Bill No. 04-R60

TITLE: PRELIMINARY PLAT NO. 03011, OUTFIELD PARK, requested by Ross Engineering, Inc. on behalf of The Dinerstein Companies, for 5 lots and 6 outlots, with associated waiver requests, on property generally located west of North 1st Street and south of Charleston Street.

Re: Preliminary Plat No. 03011
OUTFIELD PARK

LINCOLN CITY/LANCASTER COUNTY PLANNING STAFF REPORT

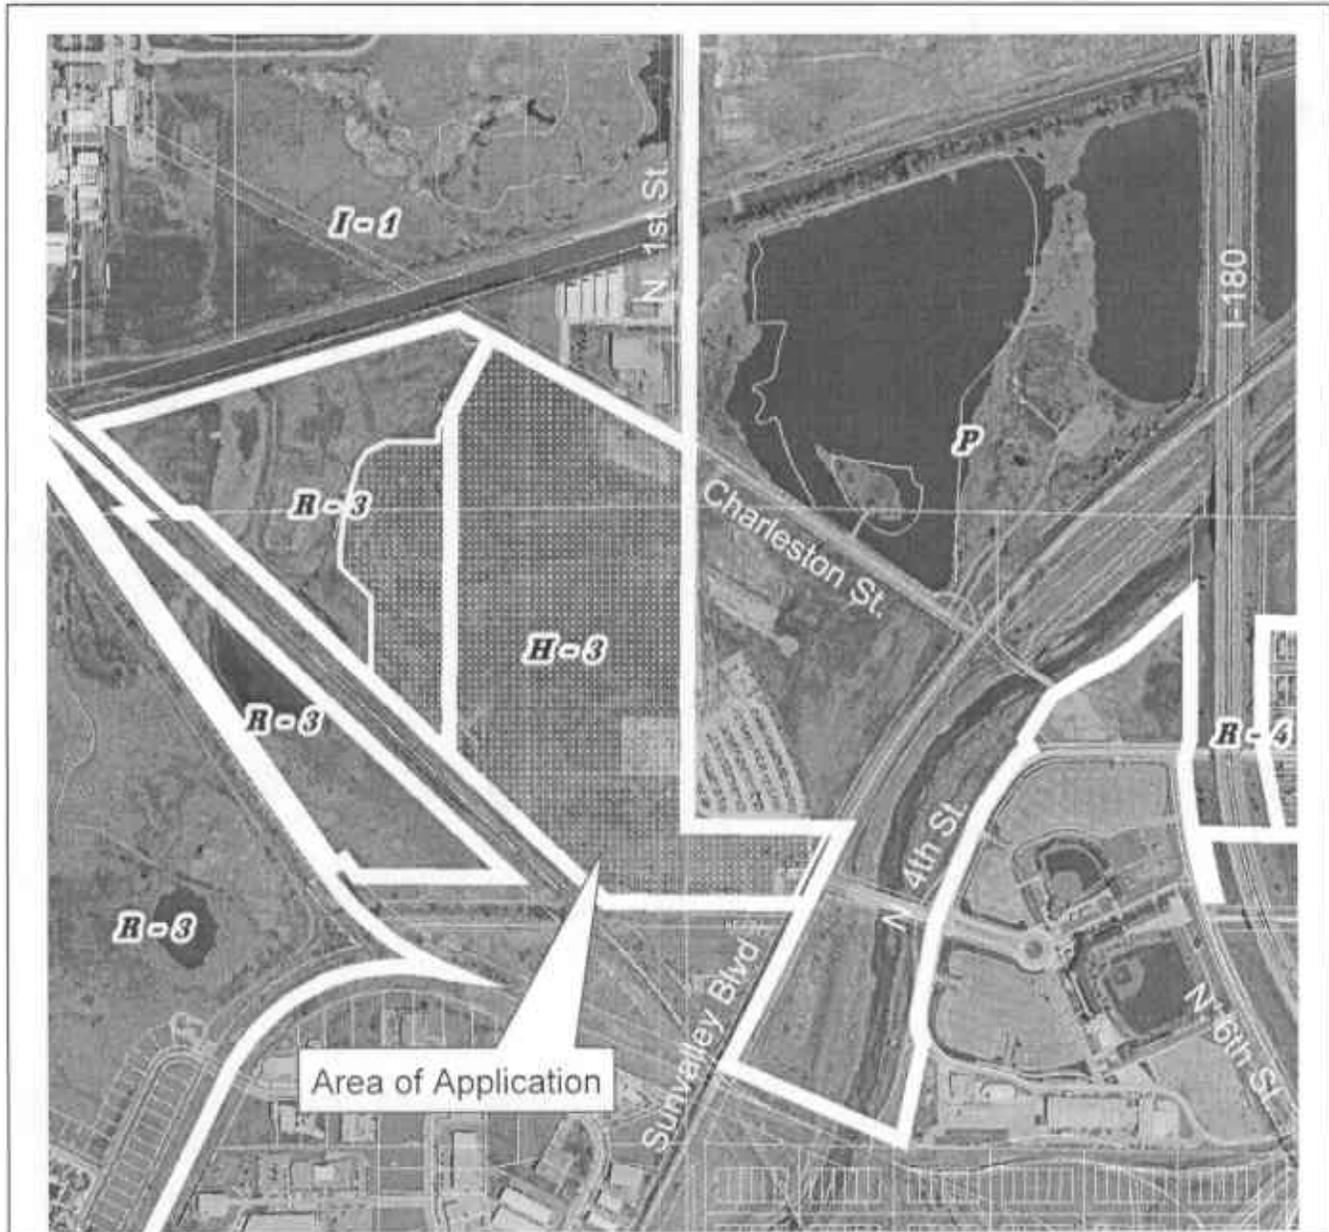
Ron: We have finished with our revisions to the Commercial area to the north. The Site Plan is updated and was delivered to Dennis this morning, and also to Greg Cz. We wanted to make sure they could look at it during their morning meeting. I've mentioned the connection to the Private Roadway entrance from the 7.5 acres, as well as several other changes:

We are modifying Outfield Park Preliminary Plat with the following revisions and corrections based on the comments we received from the Planning Department and the Planning Commission.

1. The S-shaped Private Street that ran thru the commercial area to the north has been modified to now connect to the entrance for Sterling University. The site plan shows a potential layout of commercial development along this private street. 2. A second bus stop has been added at the corner of Driveway E and Driveway B. 3. The first bus stop was moved one block east. 4. The Entrance Monument sign has been moved to the center of the median of the entrance to Phase 2. 5. The commercial area north of Dinerstein's. 6. The Mail Kiosk was accidentally removed from the previous CUP and PP, and it has been added to the drawing. 7. A portion of West Charleston Street is now shown widened by six feet, to make this 39 feet wide at First Street in order to make enough space for a turn lane. 8. Two of the Townhouse structures were swapped: the four-plex was swapped with a six plex to reduce the amount of parking required next to the wetland. One six-plex was shifted away from the existing Wetland to avoid needing retaining walls. 9. The retaining walls were deleted, and the sidewalks have been pulled closer to the apartments to avoid the wetlands. If they are needed, small retaining walls will be utilized to maintain the 25-foot buffer around the wetland. 10. The Grading Plan will be revised around wetland to have 2 to 1 slopes to avoid impacting the wetland. 11. Several parking lots were shortened and many parking stalls were removed order to maintain a 25 feet buffer next to the adjacent Wetland. 12. Line Drive (aka NW 2nd Street) is shown widened to 33-feet south of the Tow Lot Private Street, which is on the south tract of the Preliminary Plat. It tapers to 27-feet as it enters the residential area of Sterling University. 13. The landscape Buffer for H-3 is now shown on Preliminary Plat. It is a 30-foot screening around the outlots to the north and south of Sterling University Phase 2.

We have included four drawings of the site plan. Let me know if you have any questions.

EXHIBIT B

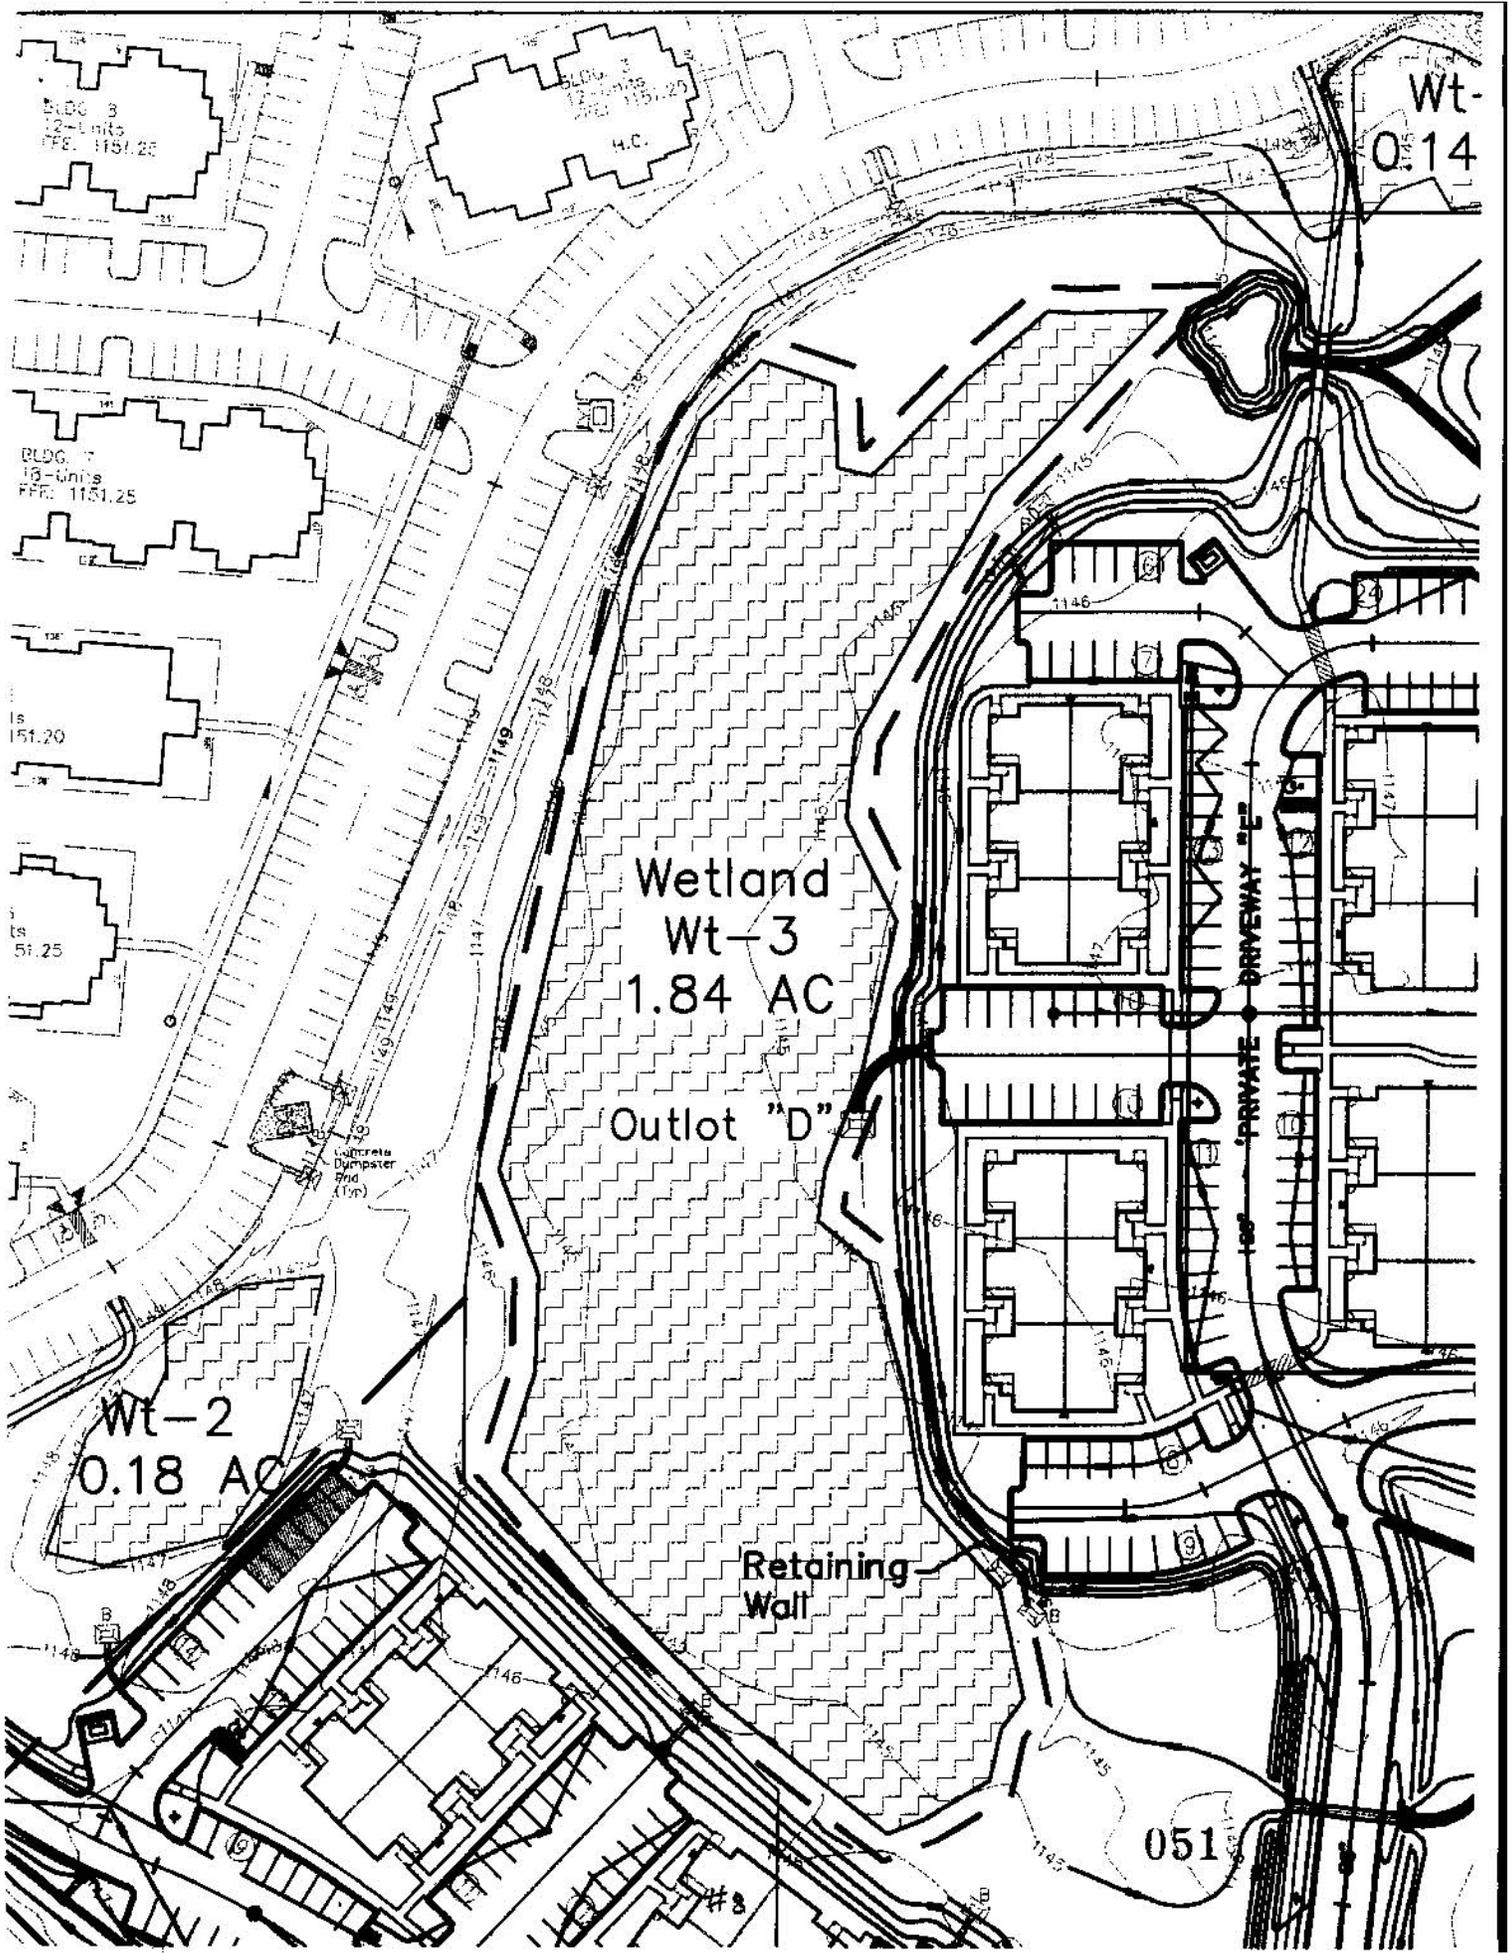
14. Applicant has provided notes on the plan that suggest different alternatives based upon three scenarios for the future use of the City tow lot (Exhibit B). These notes must be removed, and any such agreements be evaluated by the Law Department and made part of a separate document.
